FALKOS SUBDIVISION

APPLICATION NUMBER 6 DATE December 1, 2016

REQUEST Subdivision

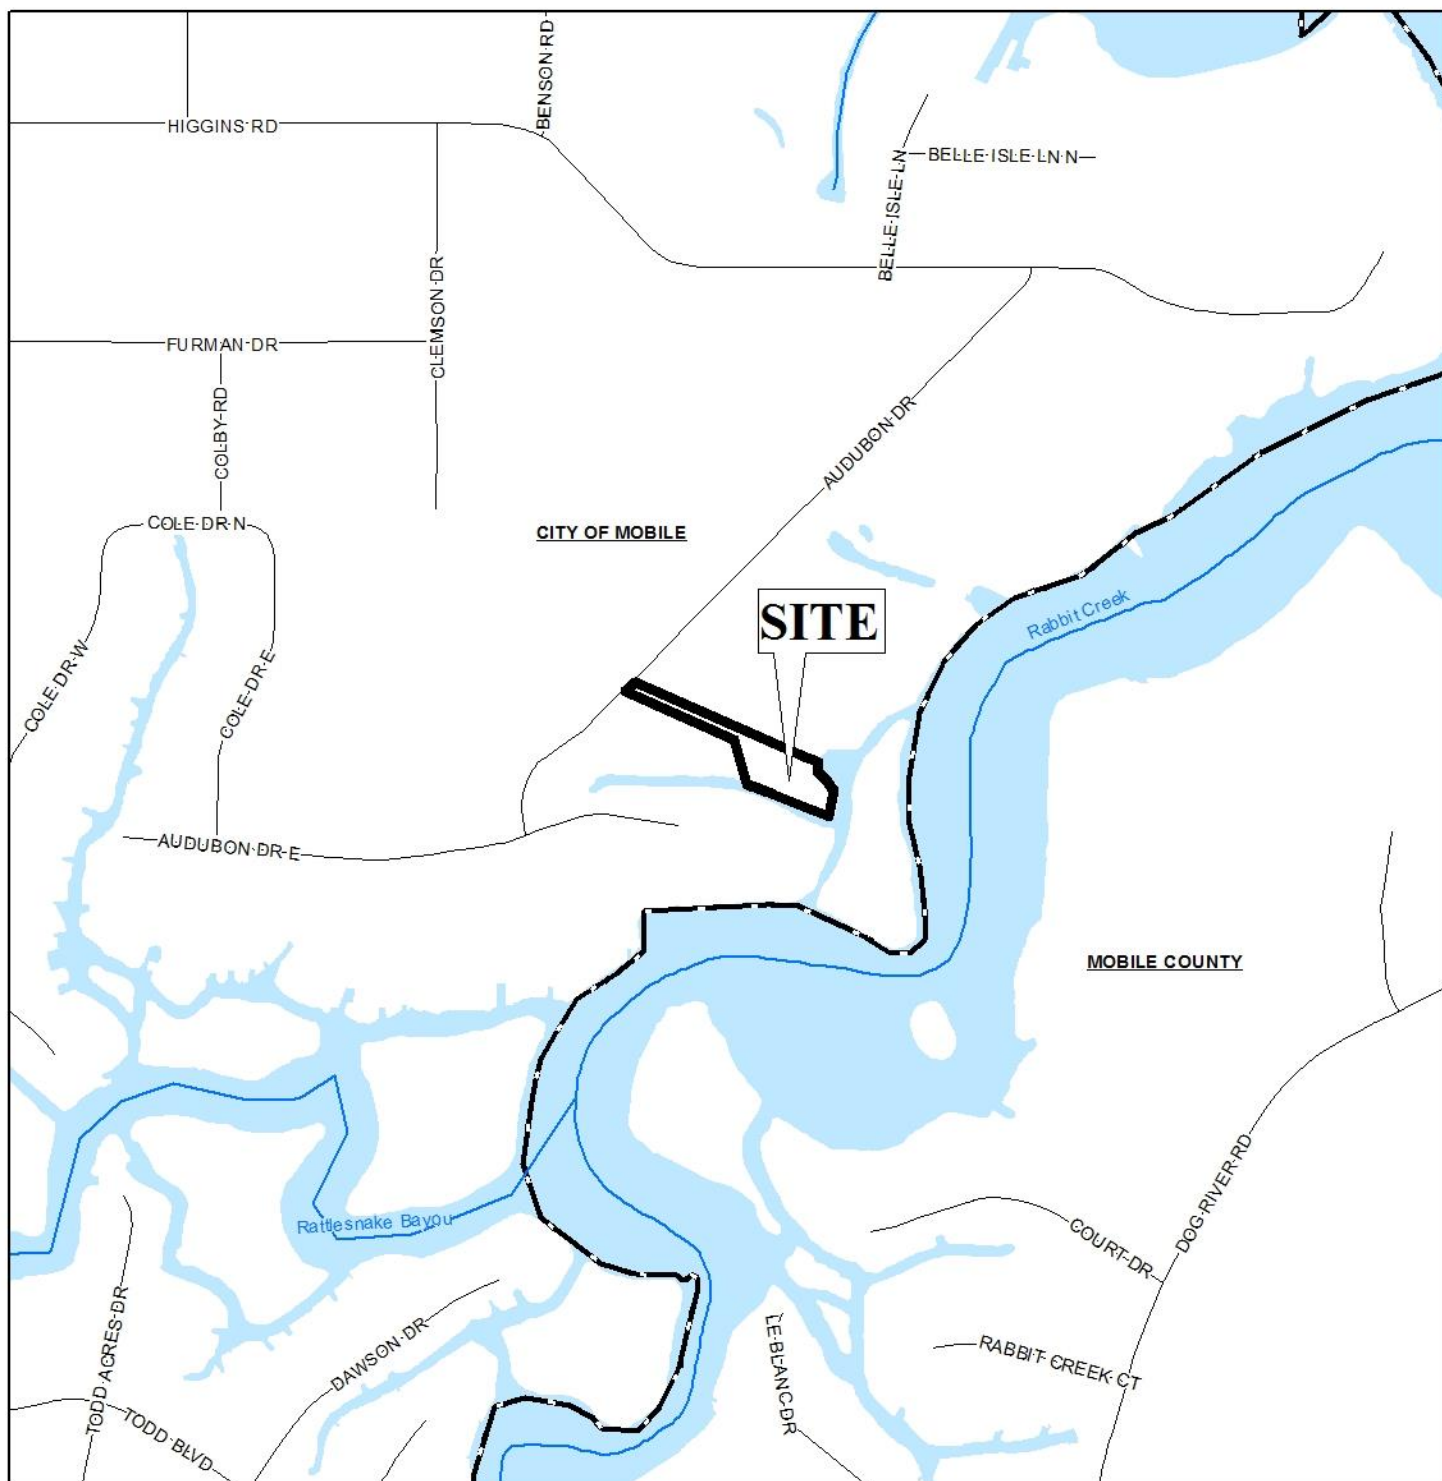
The proposed lot fronts Audubon Drive, a minor street without curb and gutter. As a minor street without curb and gutter, this street requires a 60' right-of-way width. The preliminary plat illustrates Audubon Drive as having a 50' right of way width. Dedication was not required when the lots were created in 2005, thus such should not be required for the current request. If approved, the 50' right-of-way width should be retained on the Final Plat.

A 25-foot minimum building setback line is depicted on the preliminary plat along Audubon Drive. At this location, the lot is less than 60-feet wide. The minimum building setback line should be located where the lot is at least 60' wide on the Final Plat, if approved.

The site exceeds the maximum width to depth ratio as recommended by the Subdivision Regulations; therefore, a waiver of Section V.D.3., would be required. However, narrow, deep lots are typical along waterways; thus a waiver of Section V.D.3 of the Subdivision Regulations would be appropriate.

The proposed site is situated within the floodplain and adjacent to Rabbit Creek. The approval of all applicable federal, state and local agencies would be required prior to the issuance of any building permit.

The proposed lots exceed the 7,200 square foot minimum lot size requirements for lots served by public water and sanitary sewer systems according to Section V.D.2. of the Subdivision Regulations. The Final Plat, if approved, should retain the lot size information in both square feet and in acres.

As a means of access management, a note should be placed on the Final Plat, if approved, stating that the proposed Lot 1 is limited to one curb cut to Audubon Drive, with any changes to the size, design and location of the new curb-cut to be approved by Traffic Engineering and conform to AASHTO standards.

- 1) Retention of the 50' right-of-way width along Audubon Drive;
- 2) Retention of lot size information in both square feet and acres;
- 3) Illustration of the minimum building setback line where the lot is at least 60' wide;

- 4) Placement of a note on the Final Plat stating that the proposed Lot 1 is limited to one curb cut to Audubon Drive, with any changes to the size, design and location of the new curb-cut to be approved by Traffic Engineering and conform to AASHTO standards.
